PCU072645

11 October 2017

**RE: APPLICATION NUMBER SSI 17-8285
PARRAMATTA LIGHT RAIL – WESTMEAD TO CARLINGFORD
PREMISES 151 HAWKESBURY ROAD, WESTMEAD**

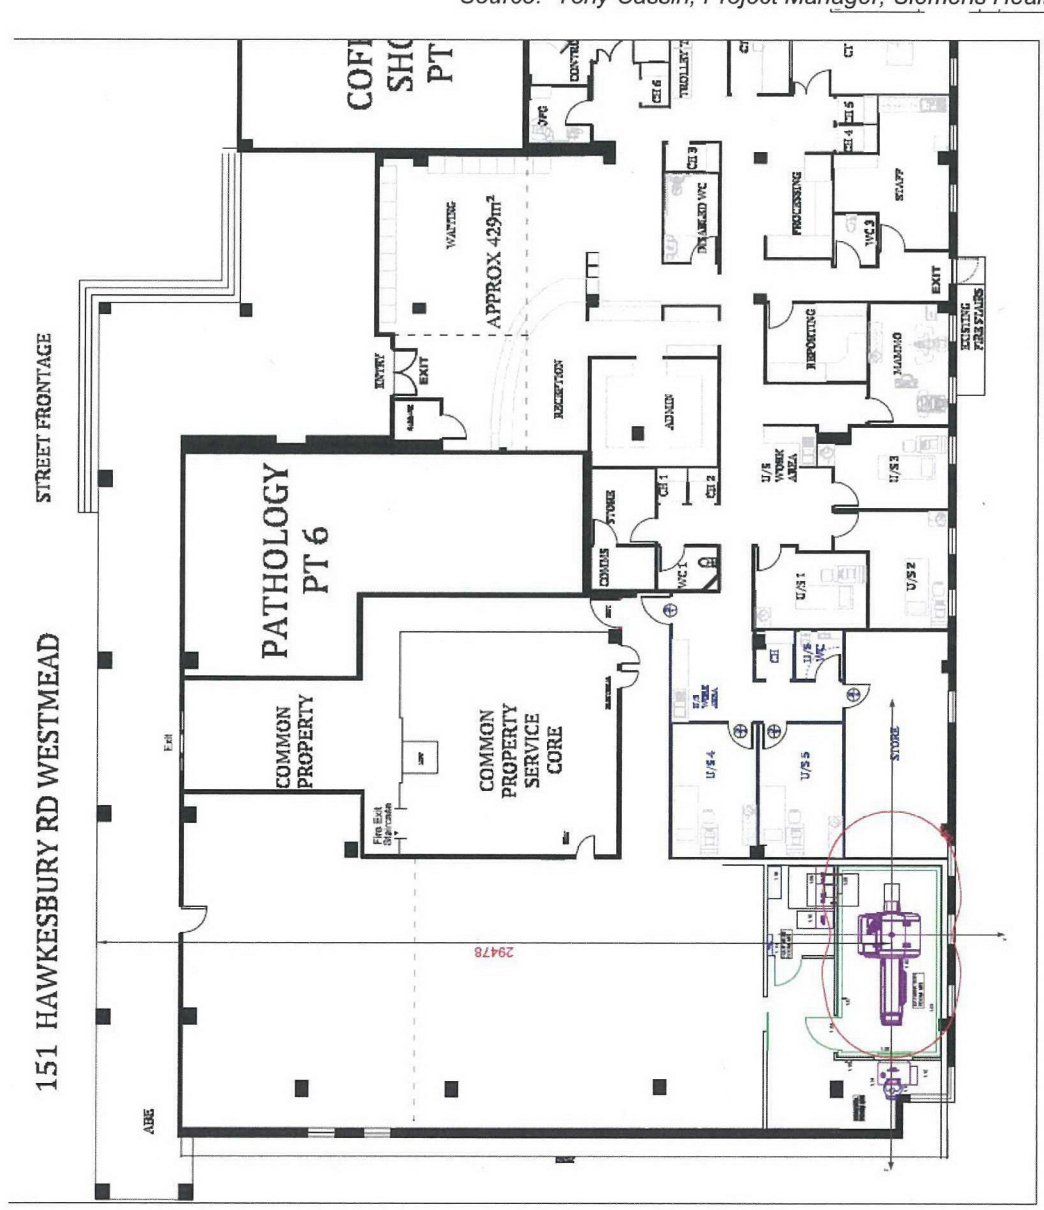
Our Client's building is shown with the red star.

Comment: The alignment of the light rail and associated infrastructure traverses past and includes part of the existing property at 151 Hawkesbury Road, Westmead.

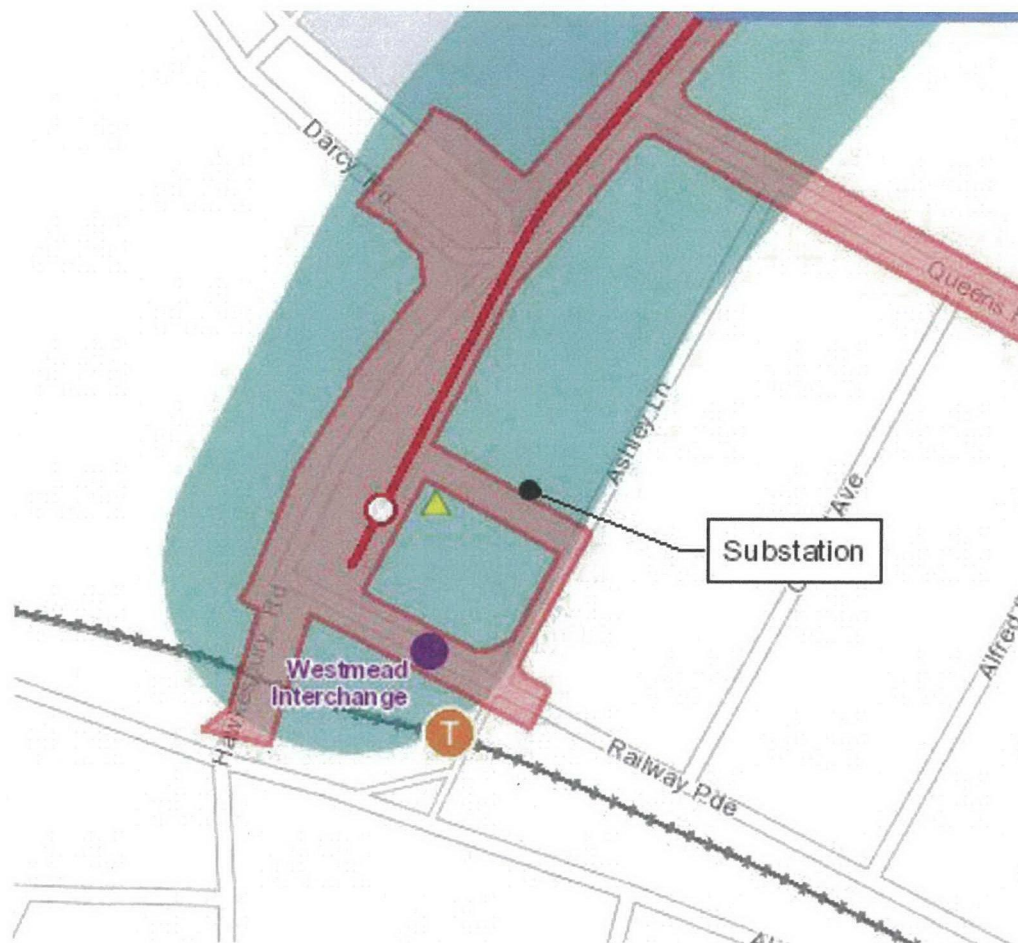
The drawing below has been prepared by Siemens Healthineers to demonstrate the proposed location of the MRI Machine and the distance between the centre of the machine and the alignment of Hawkesbury Road. Siemens have provided the following information:

- The maximum distance we can get from the isocentre of the MRI to the front of the building is 29.4m, to prevent image artefacts our planning guides require this to distance to be 40.0m from the nearest point of a train or tram.
- Looking at the first picture below and comparing with Google maps, it appears the proposed tram line will run across the front of your building with acquisition of the trees in the forecourt and the CommBank Building, we would need more detailed plans of this area to confirm that there is an additional 10.0 metres from the front of your building to the tram lines.
- The second issue is the EIS shows a substation proposed fairly close to your MRI, this requires further investigation as the mains and the substation need to be more than 15.0m away from the MRI

The project manager from Siemens also makes reference to the proposal to set up a sub-station.

The location of a MRI facility within the existing radiology practice is limited due to the location of a common property core and the design and configuration of the actual building plate on which PRP operate. It is physically impossible to locate the MRI any further than what is shown on the drawing prepared by Siemens Healthineers. A distance of 29.47m from the alignment of the new road frontage to the machine is totally inadequate and would result in the MRI not being installed which therefore means that the community would suffer due to the lack of an MRI machine being readily accessible to the existing radiology facilities. As pointed out previously, an MRI machine is now a critical component of all major radiology practices and strongly supported by State and Federal Government Health Services.

It is acknowledged that there is merit in the proposed light rail facility from the Westmead health precinct through to the Parramatta main CBD however it is only reasonable due consideration be given to the location of the existing health facilities in this immediate precinct, and, the provision of an MRI machine which will have significant benefits to the community and to other support medical facilities that are in this immediate vicinity. It is requested that the NSW Department of Planning and Environment, through the Director of Transport Assessments, re-assess the current planned alignment for the light rail adjacent to 151 Hawkesbury Road, Westmead, and relocate the main line so that there is a clear distance of 40m between the centre of the proposed MRI and the associated rail infrastructure.
